**Joint Response of  
Cherwell District Council  
and  
Oxfordshire County Council  
to the Oxfordshire Strategic Rail Freight Interchange Stage 2  
Consultation**

**November 2025**

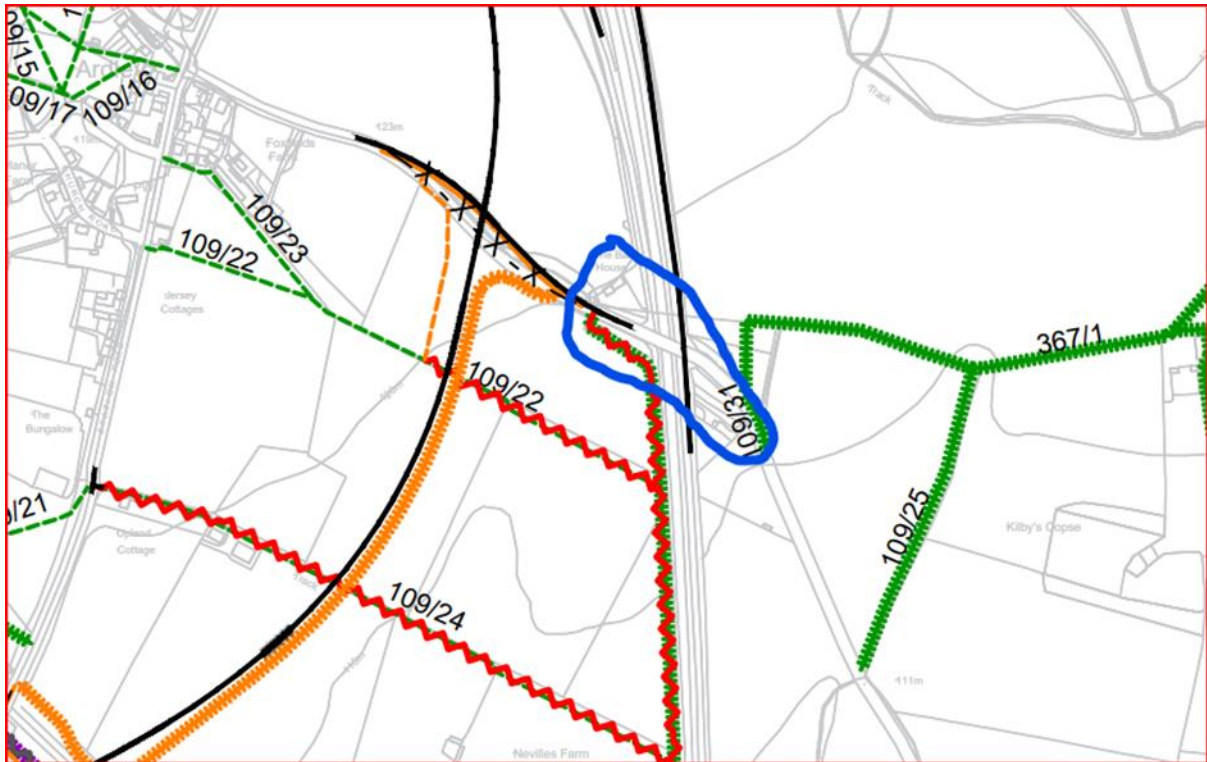
- 8.2.30 Route 4 alongside Middleton Stoney Road should be further explored. OCC would accept departure from LTN 1/20 at pinch points in terms of width and segregation, given that there would be very small numbers of pedestrians, and, while we would not support the removal of significant trees and hedges, the DCO would allow additional land behind the hedge/trees to be CPO'd where necessary. This route is more legible and direct than the other options and therefore more likely to be used. It would connect to a major active travel scheme on Middleton Stoney Road leading into Bicester. The scheme should include wayfinding along the route, within the site, and within Bicester.

- 8.2.31 Additionally, improved pedestrian facilities would be provided in Middleton Stoney, and there would be cycle connections within the site, including a publicly accessible route along the spine road (also set out in the Sustainable Transport Strategy). Appendix M of the Sustainable Transport Strategy shows how the improvements would be phased.
